SK (BAY/SOUTH) LOUNGE 01 Rev A

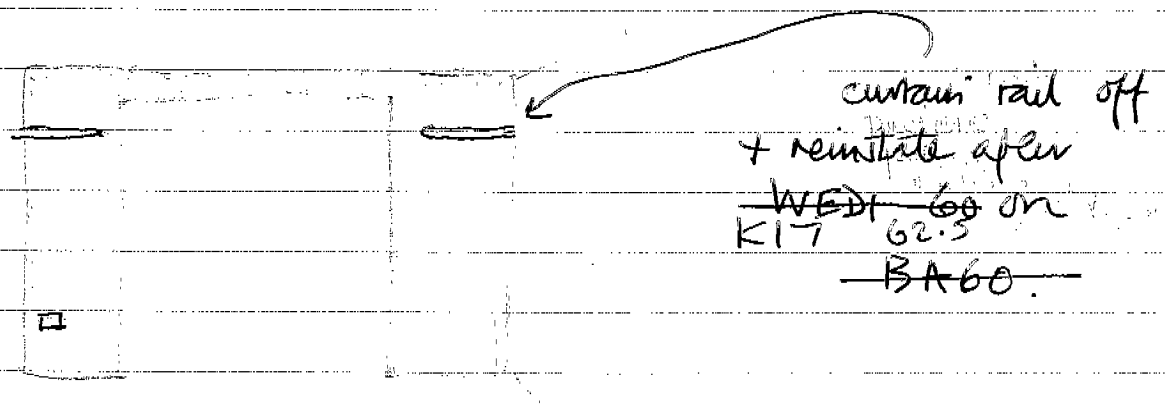
Furniture needs to be removed first.

~~WEDI 60 on~~
~~KIT 62.5~~
~~BA60.~~

~~60 slab on ceiling~~
~~as per other bay~~
~~in living room.~~

1) Carefully remove picture rail + set aside for later reuse lower down.

~~2) Put on 60mm BA 60 WEDI on ceiling~~

'Reverts' B.E.

3 N° Wedi 20mm BA20G

SK WEST LOUNGE 02

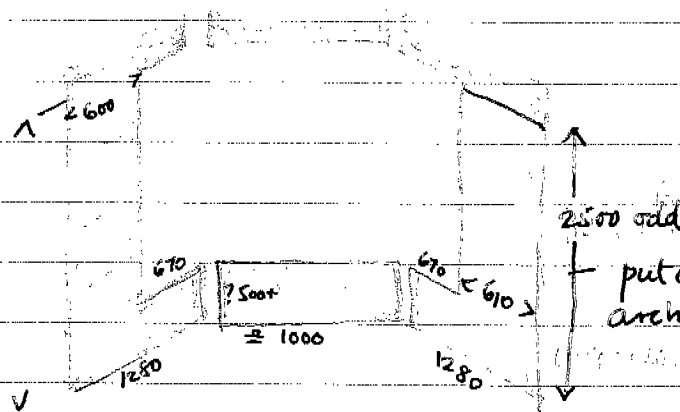
curtain rail support stays
curtain rail taken off
+ put on lower after
ceiling BR60 put on.

picture rail
